Attachment F

**Inspection Report
13-15A Bridge Street, Sydney**

**Council investigation officer Inspection and Recommendation Report
Clause 17(2), Part 8 of Schedule 5, of the Environmental Planning and Assessment
Act 1979 (the Act)**

Premises: 13 –15A Bridge Street, Sydney

Figure 1

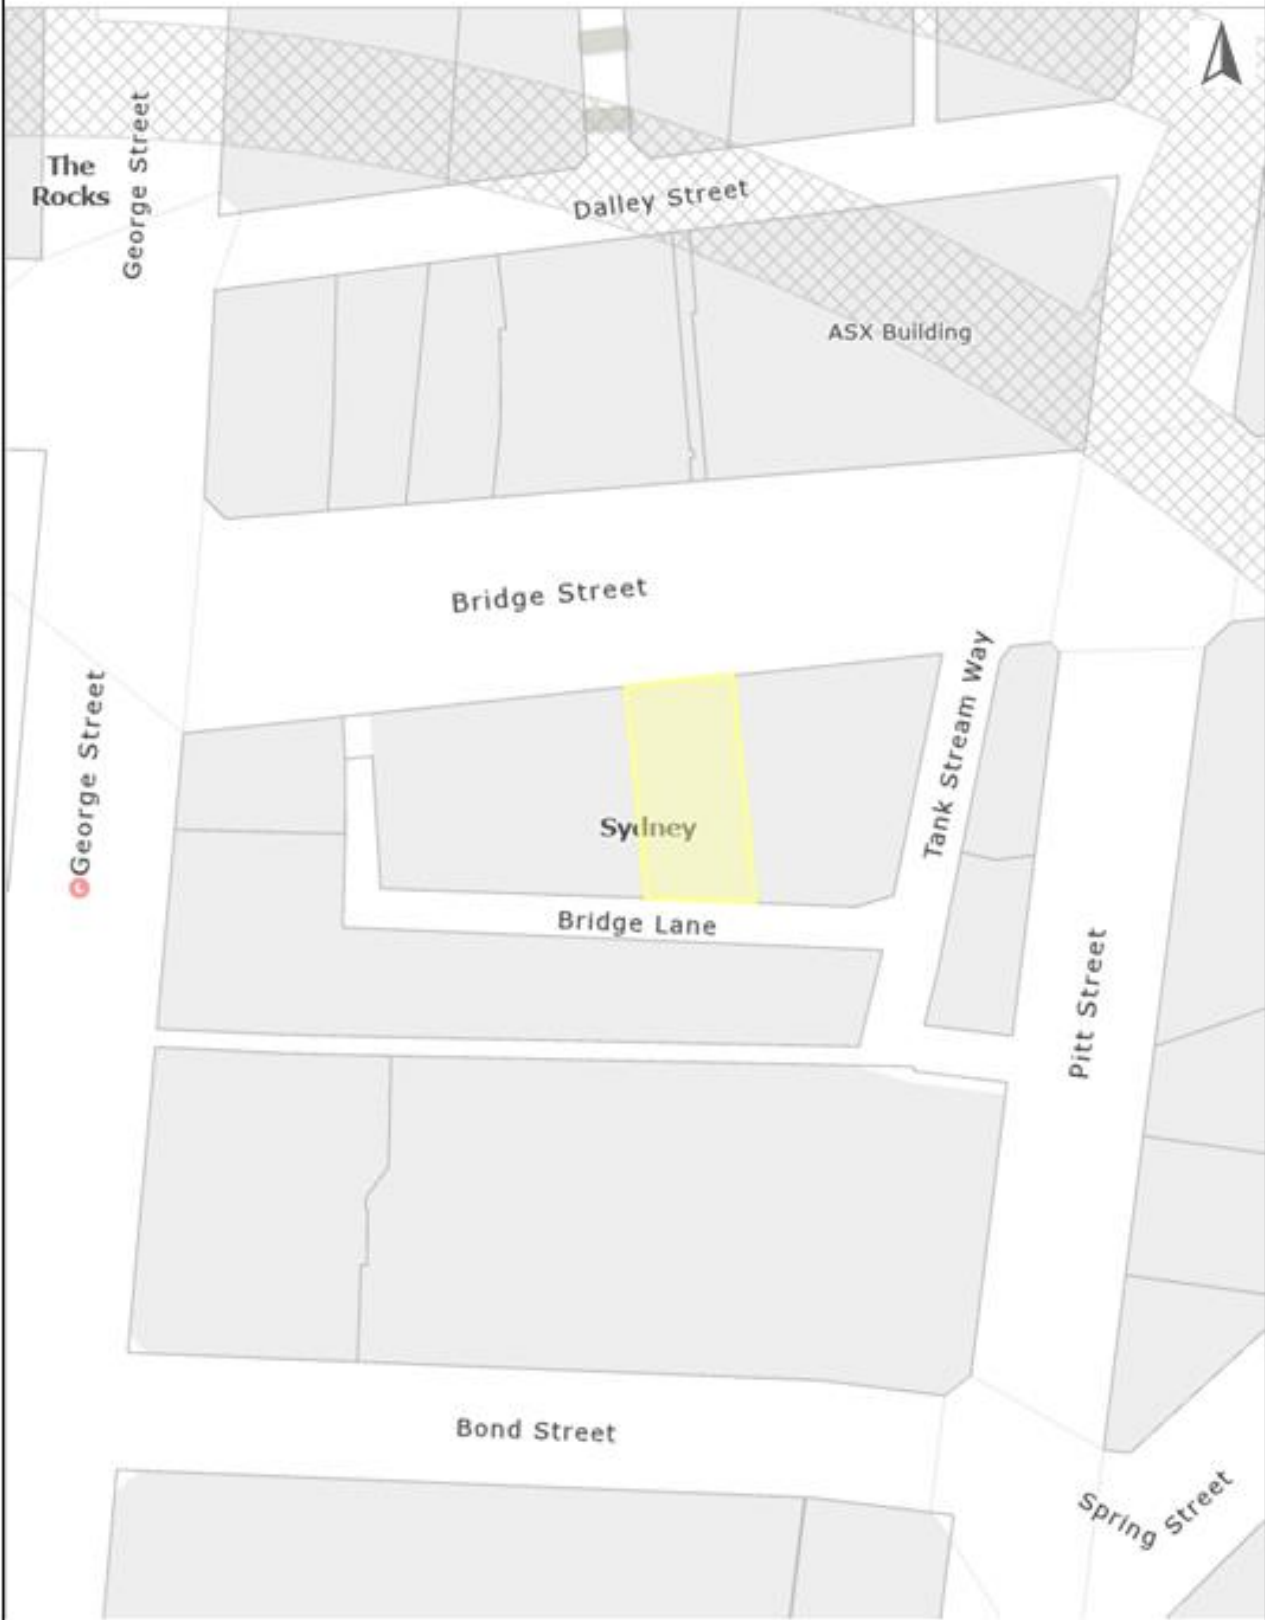
- a. At the time of inspection, the building was occupied.
- b. As a result of paintings being stored in the corridor (partitioned from carparking area) that lead to a required exit in the carpark, the unobstructed width of

1000mm was not provided, impacting on occupants ability to evacuate the building (see Figure 1).

- c. FRNSW observed a width of approximately 350mm for persons accessing the egress door.
- d. To do or refrain from doing such things specified in the Order to ensure or promote adequate fire safety or awareness.

1. Restore the path of travel to an exit, by removing the paintings that create an impediment to persons evacuating the carpark.
